Council Reference:	A007039019
Property Location:	592 Stafford Road, Stafford QLD 4053
Property Descriptions:	Lot 268 on RP69037
Development:	Development Permit for a Reconfiguration of a Lot – 1 into 3 Lot Subdivision
Client:	Dimension Legal Pty Ltd

We refer to Council's Information Request dated 1st of July 2026 made under clause 12.1 of the *Development Assessment Rules* ("DA Rules") and, on behalf of our client, and pursuant to clause 13.2(a), forward the following as a **full** response to **all** requested items.

Figure 1 – 1% Fall Sections

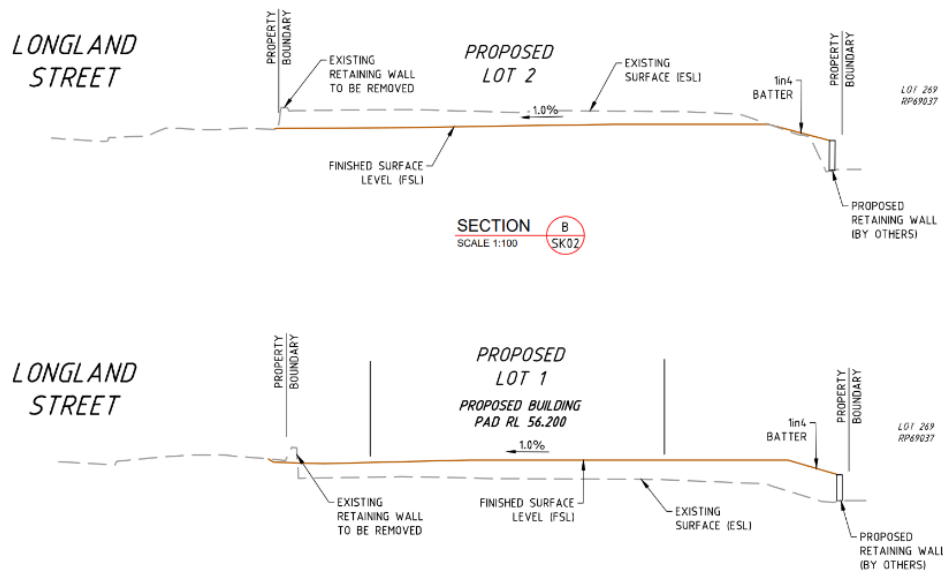
1. *The proposal states that the proposed Lots 1 & 2 will be provided individual connections to stormwater infrastructure connected to Longland Street. However, the proposed earthworks drawings do not indicate the proposed levels of the lots and, therefore, a lawful point of discharge has not been demonstrated.*
- a) *Provide amended engineering drawings, including an RPEQ endorsement, and revised earthworks sections plan that clearly showing a 1% fall of Lots 1 and 2 towards Longland Street. These amendments will result in minor level changes, which must be accurately reflected in the concept earthworks layout plan.*

Refer to Plans 5810-SK02 and SK03 Rev. PC for the amended Earthworks Layout and sections, endorsed and signed by an RPEQ, showing the proposed lot levels, including a 1% fall for Lots 1 and 2 towards Longland Street.

Sections B and C of the amended Earthworks Plans include the 1% fall towards Longland Street, extracted below. The retaining walls included at the boundary of proposed Lot 2 that range from 54.7m AHD to 54.5m AHD. Likewise, the proposed retaining walls at the boundary of proposed Lot 1 now include a peak of 56.2m which falls to 56.0m AHD at the Longland Street frontage.
